Office Action Summary

10/591,912

BOURGON ET AL.

FIG-4

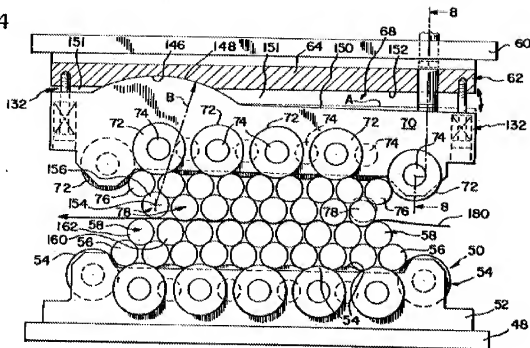
Limitations from claim 1, tensionless leveller (figure 4) intended for levelling a metal strip (180), having an entry and an exit, comprising n+1 motorized rolls (54, 56, 58, 72, 76, 78), of the type comprising two superposed cassettes (48, 60) each supporting at least n/2 rolls (54, 56, 58, 72, 76, 78) of constant radius R, offset with respect to one another and placed alternately above and below the path of the strip (180), the axis of each of the rolls (54, 56, 58, 72, 76, 78) of one cassette (48, 60) being separated from the axis of the immediately successive roll (54, 56, 58, 72, 76, 78) of the other cassette by a centre-to-centre spacing E_k , in which:

for k from 2 to 4, $R/E_k = R/E_1$;

for k from $n-3$ to n , $R/E_k = R/E_n$ and $R/E < R/E_1$; and

for k from 5 to $n-1$, $R/E_n \leq R/E_k \leq R/E_1$, and $R/E_k \leq R/E_{k+1}$, said leveller (figure 4) optionally including means for adjusting the centre-to-centre spacings E_k (column 2, lines 61-65) (column 3, lines 5-64).

Bradlee discloses the claimed invention except for the center-to-center spacing ratios. It would have been obvious to one having ordinary skill in the art at the time the invention was made to design the apparatuses with precise center-to-center spacing ratios, since it has been held that where the general conditions of a claim are disclosed in the prior art, discovering the optimum or workable ranges involves only routine skill in the art. *In re Aller*, 105 USPQ 233.

Limitations from claim 2, leveller (figure 4) according to claim 1, in which $n \geq 8$ (column 3, lines 5-64).

Bradlee discloses the claimed invention except for explicit enumeration of the rolls. It would have been obvious to one having ordinary skill in the art at the time the invention was made to add additional rolls to the invention, since it has been held that mere duplication of essential working parts of a device involve only routine skill in the art. Additional rolls to the leveller would result in a smoother, more defect-free product. *In re Regis Paper Co. v. Bemis Co.*, 193 USPQ 8.

Limitations from claim 3, leveller (figure 4) according to either of claims 1 and 2, in which, when the thickness of the strip (180) to be levelled is between 0.5 and 3 mm, $14 \leq n \leq 22$ (column 3, lines 5-64).

Bradlee discloses the claimed invention except for the optimal range of metal strip thickness. It would have been obvious to one having ordinary skill in the art at the time the invention was made to design the invention for a specific metal strip thickness, since it has been held that where the general conditions of a claim are disclosed in the prior art, discovering the optimum or workable ranges involves only routine skill in the art. *In re Aller*, 105 USPQ 233.

Limitations from claim 4, leveller (figure 4) according to either of claims 1 and 2, in which, when the thickness of the strip (180) is between 3 and 15 mm, $10 \leq n \leq 16$ (column 3, lines 5-64).

Bradlee discloses the claimed invention except for the optimal range of metal strip thickness. It would have been obvious to one having ordinary skill in the art at the time the invention was made to design the invention for a specific metal strip thickness, since it has been held that where the general conditions of a claim are disclosed in the prior art, discovering the optimum or workable ranges involves only routine skill in the art. *In re Aller*, 105 USPQ 233.

Limitations from claim 5, leveller (figure 4) according to any one of claims 1 to 4, in which:

for k from 1 to x, $0.90 \leq R/E_k \leq 0.95$; and

for k from x+1 to n, $0.70 \leq R/E_k \leq 0.80$. (column 3, lines 5-64).

Bradlee discloses the claimed invention except for the center-to-center spacing ratios. It would have been obvious to one having ordinary skill in the art at the time the invention was

made to design the apparatuses with precise center-to-center spacing ratios, since it has been held that where the general conditions of a claim are disclosed in the prior art, discovering the optimum or workable ranges involves only routine skill in the art. *In re Aller*, 105 USPQ 233.

Limitations from claim 6, leveller (figure 4) according to any one of claims 1 to 4, in which:

for k from 1 to x, $0.90 \leq R/E_k \leq 0.95$;

one of the centre-to-centre spacings E_x , where $5 \leq x \leq n-4$, being such that:

$0.80 \leq R/E_x \leq 0.90$;

and for k from x+1 to n, $0.70 \leq R/E_k \leq 0.80$. (column 3, lines 5-64)

Bradlee discloses the claimed invention except for the center-to-center spacing ratios. It would have been obvious to one having ordinary skill in the art at the time the invention was made to design the apparatuses with precise center-to-center spacing ratios, since it has been held that where the general conditions of a claim are disclosed in the prior art, discovering the optimum or workable ranges involves only routine skill in the art. *In re Aller*, 105 USPQ 233.

Limitations from claim 7, leveller (figure 4) according to any one of claims 1 to 4, in which:

for k from 1 to x, $0.90 \leq R/E_k \leq 0.95$;

one of the centre-to-centre spacings E_x , where $5 \leq x \leq n-4$, being such that:

$$0.80 \leq R/E_x \leq 0.90, \text{ and } 0.75 \leq R/E_{x+1} \leq 0.85; \text{ and}$$

for k from $x+2$ to n , $0.70 \leq E_k \leq 0.80$. (column 3, lines 5-64)

Bradlee discloses the claimed invention except for the center-to-center spacing ratios. It would have been obvious to one having ordinary skill in the art at the time the invention was made to design the apparatuses with precise center-to-center spacing ratios, since it has been held that where the general conditions of a claim are disclosed in the prior art, discovering the optimum or workable ranges involves only routine skill in the art. *In re Aller*, 105 USPQ 233.
